Connector Terminal Appearance Comparison :-

Connector Terminal Soldering Result :-

Connector Terminal A
product

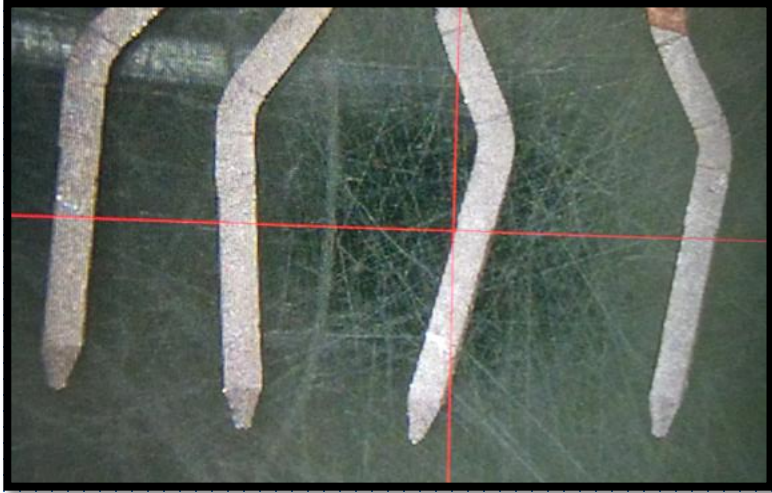
Observation – Plating on A Product Connector terminal done on all 4 side
But In B product connector plating done on 2 side only.

Connector Terminal B
product

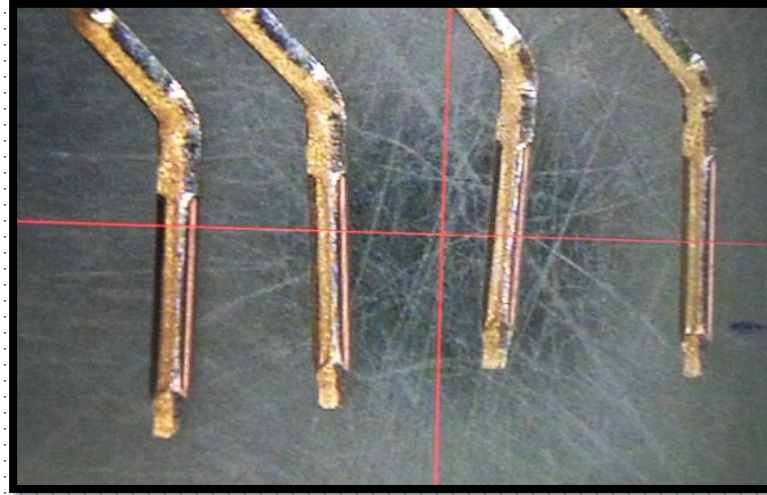
Remarks – Uneven Plating may cause for terminal soldering issue
